Access Compliance Report Public Rights-of-Way (Curb Ramps)

Main Street: CHANNING_WAY Cross Street: FOSTER_RD Location: NW

ADA ID: RPAT211206114748 Ramp Type: Type 1 - Perpendicular Diagonal Initial Pass/Fail: Fail Overall Compliance: No Severity Score: 15

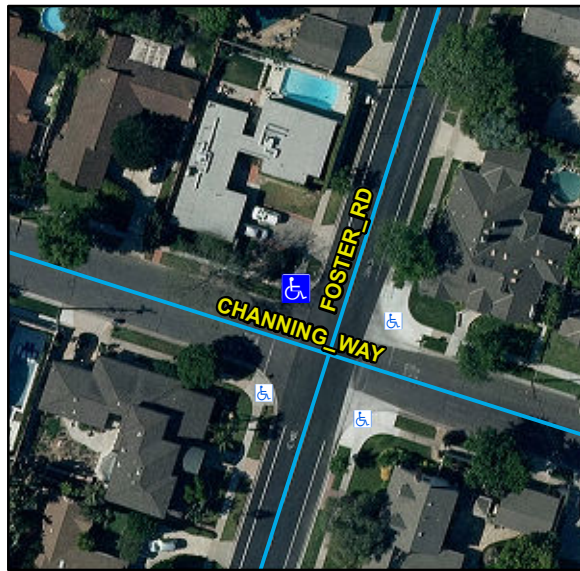
Compliance	Description	Data	Compliance	Description	Data
N/A	Ramp Length (in)	86	N/A	Flare Type LT	
Yes	Ramp Width (in)	53			N/A
No	Ramp Run Slope (%)	8.5	N/A	Flare Slope LT (%)	N/A
Yes	Ramp Cross Slope (%)	0.7	N/A	Flare Traversable LT	N/A
N/A	Landing Present	N/A	N/A	Flare Type RT	
N/A	Landing Length (in)	N/A			N/A
N/A	Landing Width (in)	N/A	N/A	Flare Slope RT (%)	N/A
N/A	Landing Run Slope (%)	N/A	N/A	Flare Traversable RT	N/A
N/A	Landing Cross Slope (%)	N/A	N/A	DWS Provided	N/A
N/A	Landing Movement Obstructed?	N/A	N/A	DWS Contrast	N/A
	Landing Movement Type	N/A	N/A	DWS Length (in)	N/A
N/A	Landing Shared	N/A	N/A	DWS Full Width	N/A
N/A	Clear Space	Yes	N/A	DWS Offset Left (in)	N/A
N/A	Clear Space To Crosswalk (in)	N/A	N/A	DWS Offset Right (in)	N/A
N/A	Marked Crosswalk 1	No	N/A	Marked Crosswalk 2	No
	Crossing 1 Direction	SW		Crossing 2 Direction	SE
	Marked Crosswalk 1 Width (in)	N/A		Marked Crosswalk 2 Width (in)	N/A

Remove & Replace Curb Ramp With Two New Directional Ramps or Equivalent.
